re: Geotechnical Grading and Site Servicing Plans Review
Proposed Industrial Development
295 Roger Neilson Way - Ottawa, Ontario

date: August 27, 2026

file: PG7845-MEMO.02

Reference should be made to Figure 3 – Marked-Up Site Servicing Plan, attached to the current memorandum, for the location of pipes where insulation will be required.

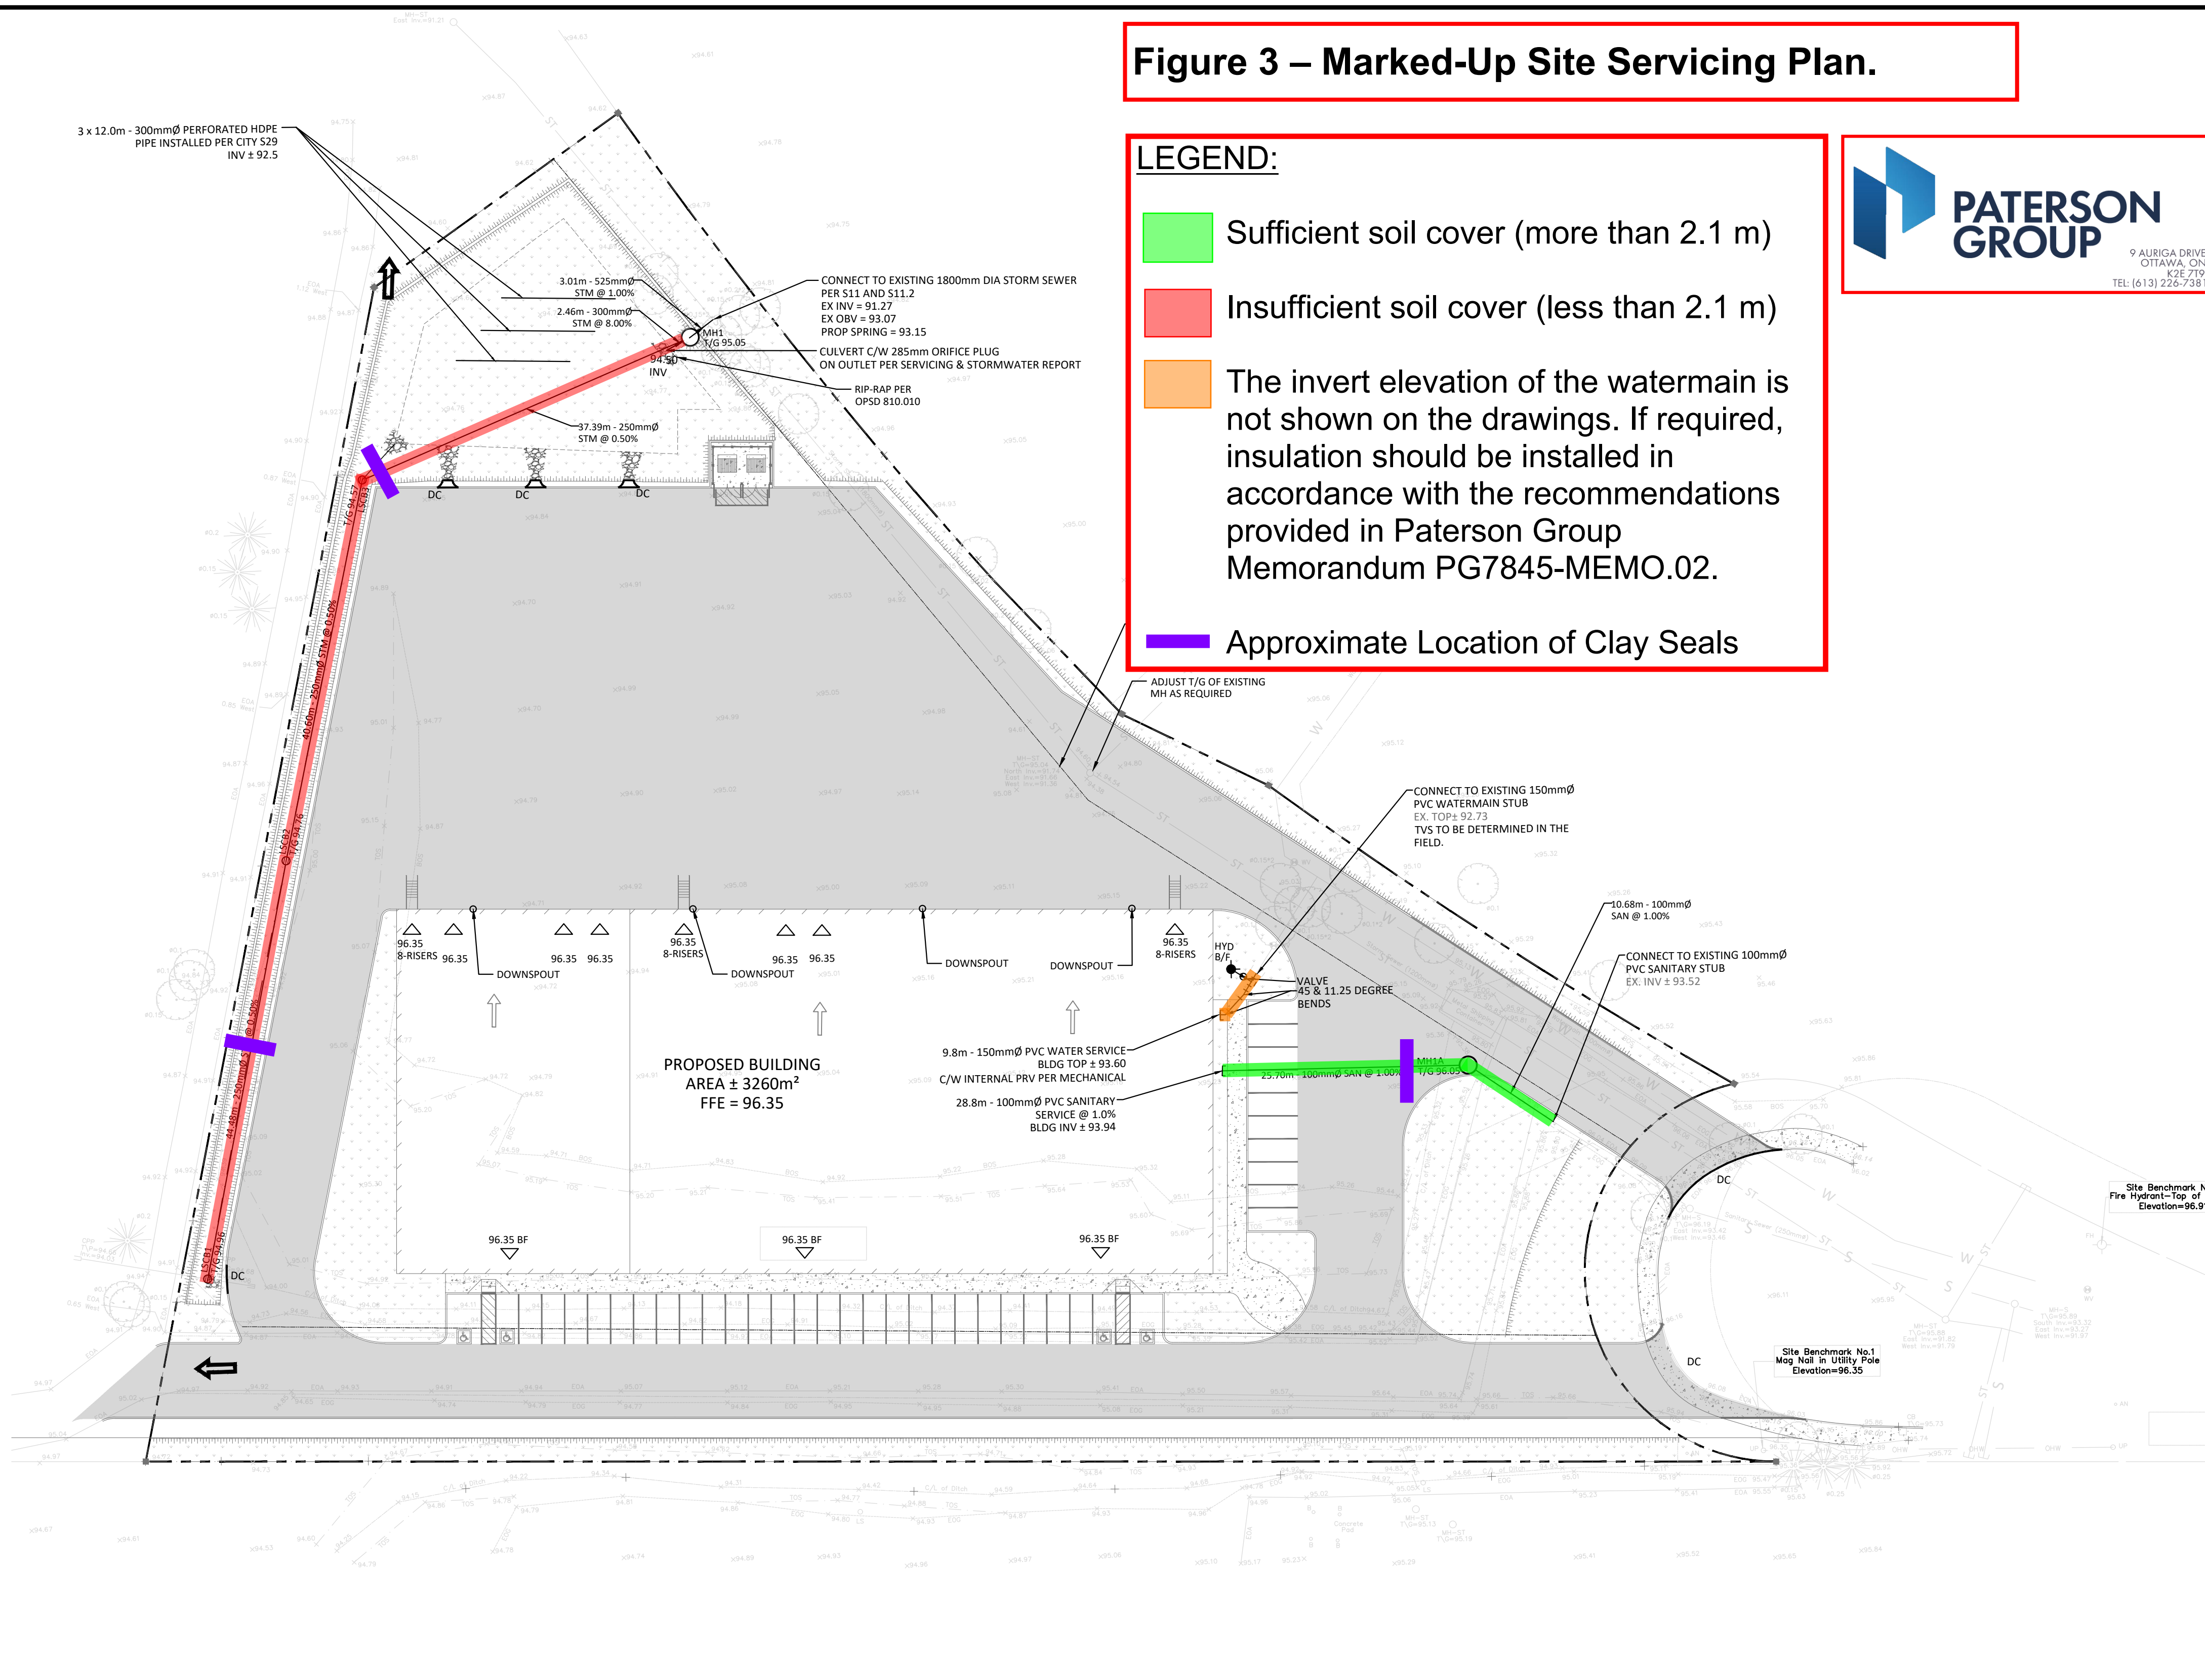
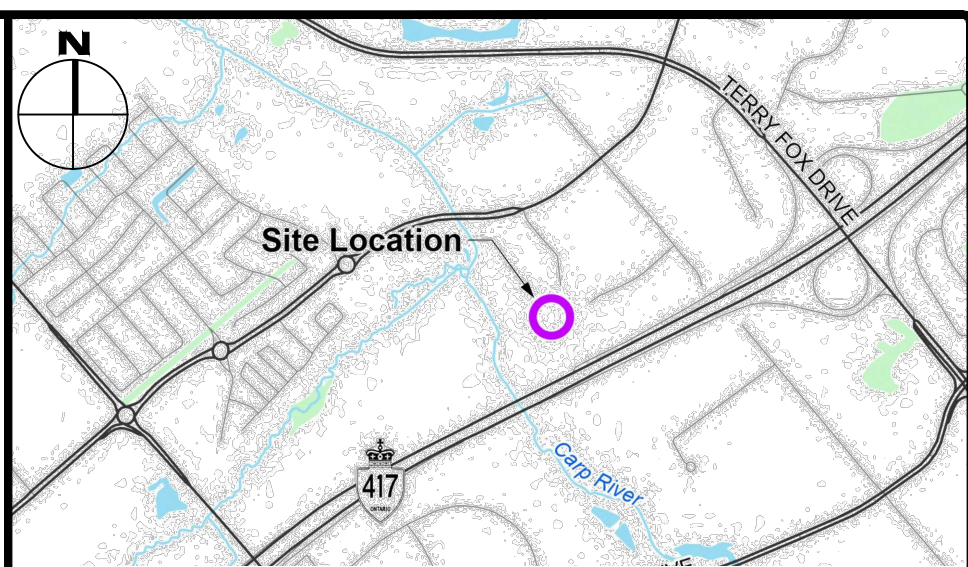
Based on our review of the above-noted site service plans, it should be noted that all services will be constructed outside the lateral zones of the proposed footings of the building and are considered to be acceptable from a geotechnical perspective. However, insufficient frost protection has been provided for all proposed storm sewer pipes throughout the subject site. The proposed services are located within the frost zone, approximately 2.1 m below the finished grade. In the following section, frost protection of the site servicing is recommended where insufficient frost cover has been provided.

It should be noted that the invert elevation of the watermain pipes has not been presented in the above-noted site servicing drawings. Therefore, if insufficient soil cover is provided for watermain pipes, rigid insulation should be installed for the proposed watermain pipes as recommended in the above table (Table 1).

In addition, to reduce long-term lowering of the groundwater at this site, clay seals should be provided within the service trenches excavated through the silty clay deposit. The seals should be at least 1.5 m long (in the trench direction) and should extend from trench wall to trench wall. The seals should extend from the frost line and fully penetrate the bedding, subbedding, and cover material. The barriers should consist of relatively dry and compactable brown silty clay placed in maximum 300 mm thick loose layers and compacted to a minimum of 95% of the SPMDD. The clay seals should be placed at the site boundaries and at strategic locations at no more than 60 m intervals in the service trenches excavated through the silty clay deposit.

Reference should be made to Figure 3 – Marked-Up Site Servicing Plan, attached to the current memorandum, for the approximate location of clay seals at the subject site.

☐ Insufficient soil cover (less than 2.1 m)

The invert elevation of the watermain is not shown on the drawings. If required, insulation should be installed in accordance with the recommendations provided in Paterson Group Memorandum PG7845-MEMO.02.

■ Approximate Location of Clay Seals

TYPICAL FROST INSULATION DETAIL

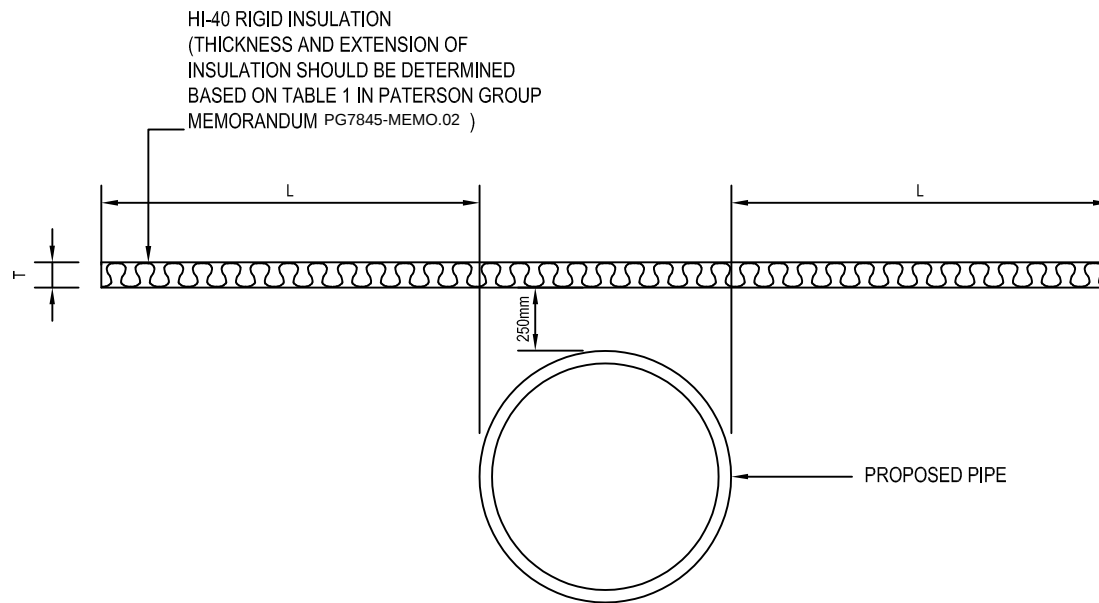
Any portion of the services installed at a depth of 2.1 m below finished grade or deeper is considered to have sufficient soil cover for frost protection. Where insufficient soil cover is present above the invert of storm sewer pipe, the following frost protection criteria should be followed:

All rigid insulation should consist of either Dow Chemical High-Load 40 (HI-40), Styro Rail SR.P400, or equivalent approved by Paterson. The placement of all insulation within the service trenches must be reviewed and approved by Paterson personnel at the time of construction. Reference should be made to Figure 4 – Typical Frost Insulation Detail, attached to this memorandum.

Table 1 - Rigid Insulation Recommendations for Pipes with Reduced Soil Cover			
Thermal Condition	Soil Cover Provided (mm)	Insulation Dimensions	
		Thickness (mm)	Extension (mm)
Unheated	600 to 900	125	Extend 1200 mm horizontally beyond edge face of the pipe
	900 to 1200	100	Extend 1200 mm horizontally beyond edge face of the pipe
	1200 to 1500	75	Extend 900 mm horizontally beyond edge face of the pipe
	1500 to 1800	50	Extend 600 mm horizontally beyond edge face of the pipe
	1800 to <2100	25	Extend 300 mm horizontally beyond edge face of the pipe
Notes: All designs are based on a freezing index of 1000°C-days
